## **Introductory Remarks**

This letter represents an initial and partial response to the Information Request dated May 28, 2020 in relation to the above-captioned investigation on behalf of Volkswagen Group of America and Volkswagen AG (collectively referred to herein as “Volkswagen” or “VW”). We note that while the agency upgraded the investigation on July 3, 2018, after Volkswagen’s response to the Information Request associated with the Preliminary Evaluation, Volkswagen believed in good faith that ODI was reviewing and considering the information previously provided, as well as Volkswagen’s conclusion that the separation of the seat belt webbing that occurred in the \*MY 2018 NCAP tests was an artifact of the way in which the ADT cable was routed and does not reflect a potential unreasonable risk to motor vehicle safety in the real world. ODI reached out to VW in May 2020, met with the company on May 28, and issued the current Information Request that same day. Volkswagen has endeavored to provide as much information as possible at this time. Volkswagen will provide more complete information according to the dates agreed to with ODI and will, beyond that, supplement its respo

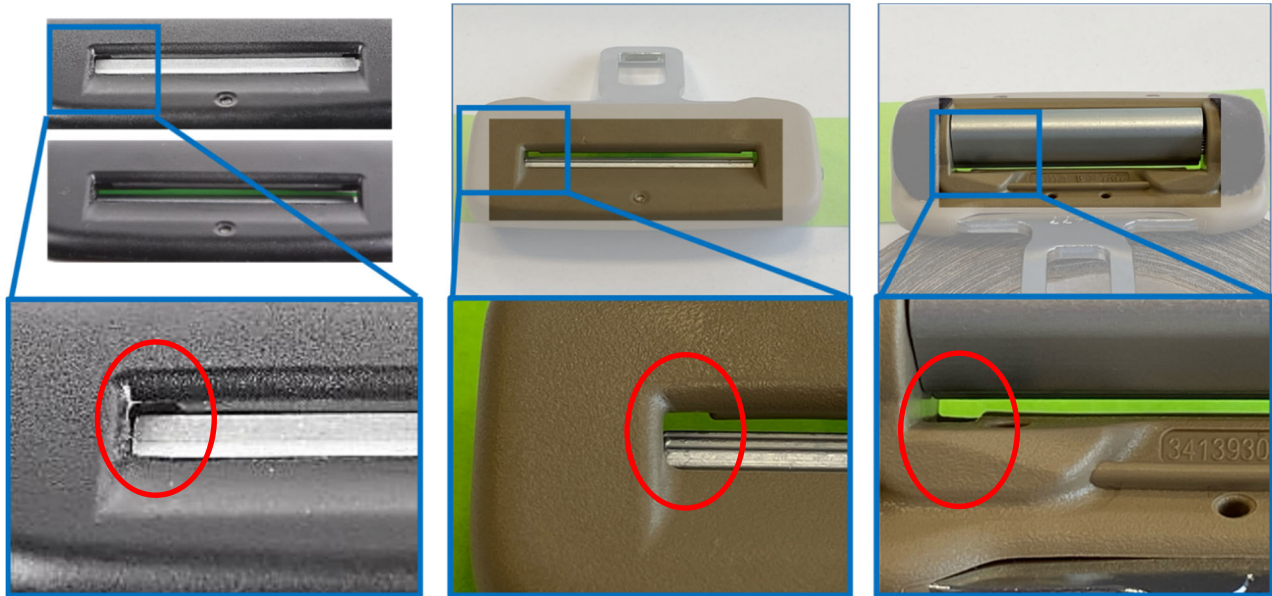
ODI stated its belief that a clamping width of 60% of the webbing width appears to be unique to the VW DLT-1 design, and that a full clamping width is preferable. During VW's development process, the opposite was found to be true – it was found that a full width clamping of the webbing could allow the webbing to tear more easily and to fray at the edges. The supplier (ZF-TRW) provided an improved, patented design to reduce the potential for tearing or fraying incorporating the more limited clamping width (Patent – US 2015/0314749 A1). Moreover, while the VW DLT-1 Volkswagen Group design is specific to the VW Group, the concept of limiting the clamping width is not. This is evidenced by the fact that Autoliv also has a patent covering a reduced clamping width design (Patent – US 2016/0206050 A1) and competitors vehicles have applied design features of the Autoliv patent.

VW provides the following table as an overview of various CLT designs available. In this table, VW references the clamping width for the different CLT models.

The Autoliv CLT-Ri has a clamping width that is comparable to the VW DLT-1 supplied by Volkswagen.  
Photo documentation of each of the CLT's can be provided if required.

The DLT-1 from ZF-TRW, supplied to the Ford F-150 MY 2018 and younger, for example, is believed to have been shown by ODI during the meeting with VW on May, 28, 2020. The agency showed this DLT-1 from ZF-TRW as an example of a CLT with a 100% clamping width.

It is Volkswagens assessment, that the DLT-1 from ZF-TRW has notches in both ends of the webbing slot that can be seen in NHTSAs picture below, that have the effect that the counter support to the "100% cam" is shorter than the cam itself. The width of the notches are about 3 mm each, so that the cam width of 52mm results in an active clamping width of 46mm or 88%.

Figure 1. Autoliv CLT-R (original design)

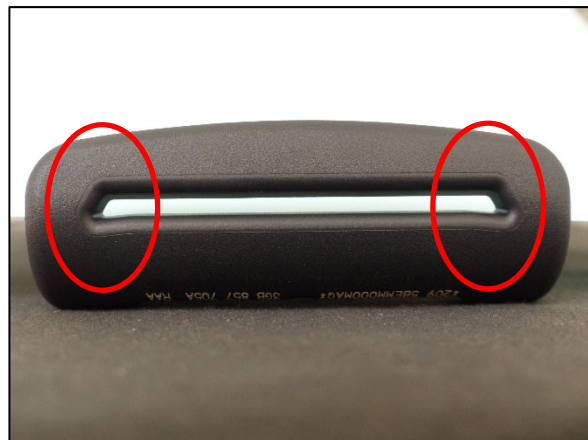
VW understands ODI's concern about a less than complete clamping width to be that such a design could potentially provide more room for the webbing to bunch, thus increasing the potential for bunching. By providing the webbing with more space for insertion (reducing the clamp width, recesses in the housing), the design helps to reduce the load path concentrations.

Figure 2. Autoliv CLT-Ri (new design)

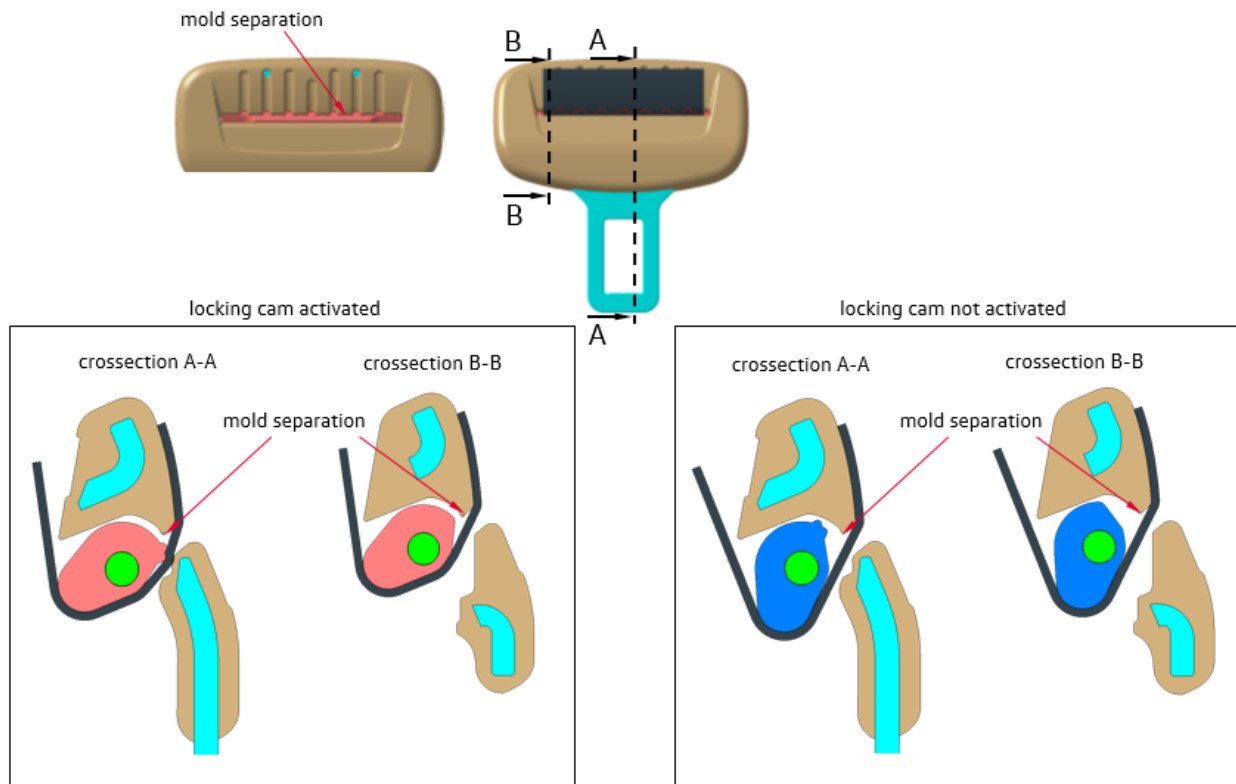
The analysis of CLTs that are available in the market also indicate that Autoliv incorporated a wider opening at the outer side of the webbing slot, as can be seen in Figure 1 and Figure 2. (Which is used, for example, in GM, Daimler, FCA, BMW, Ford, Nissan, Subaru and Tesla vehicles of recent MYs.)

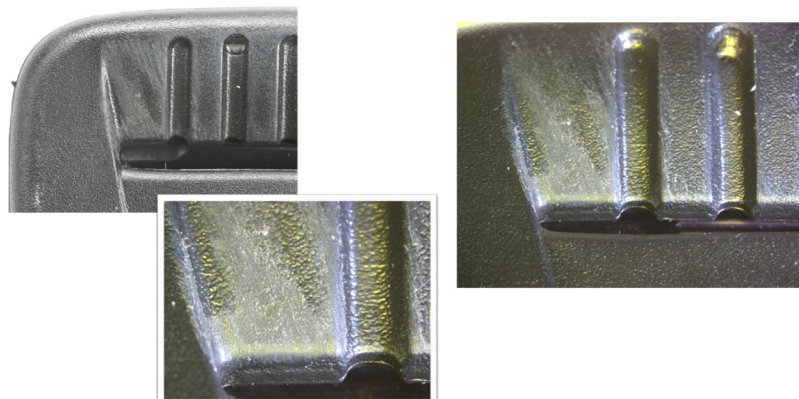
ODI observed that the separation line (ridge) from the molding tools of the VW DLT-1 provides a sharp edge which may have cut the webbing during the NCAP crashes. The webbing does not touch the mold separation ridge in any of the cam positions and the separation line is not a factor in belt performance:

The polymer housing is not strong enough to damage the webbing. Photos from NHTSA's NCAP tests show abrasion and deformation on the working surface of the VW DLT-1 housing, not at the ridge.

Figure 01: Pelvic forces < 10kN

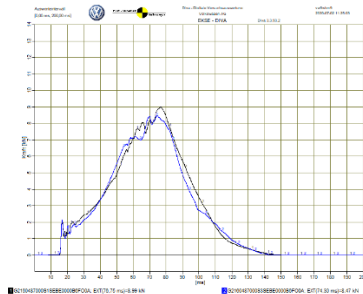
During this test there was no webbing damage or "bunching" (see figure 02). However, the pelvic forces were relatively low for an overload test (see figure 01: SP1: 8.99 kN / SP3: 8.47 kN), which does not meet the requirements of a worst case scenario. The pelvic force is an indicator of the load that has occurred on the belt system. Accordingly, it was decided to repeat the test with a synthetic pulse in order to put more strain on the belt system with increased load.
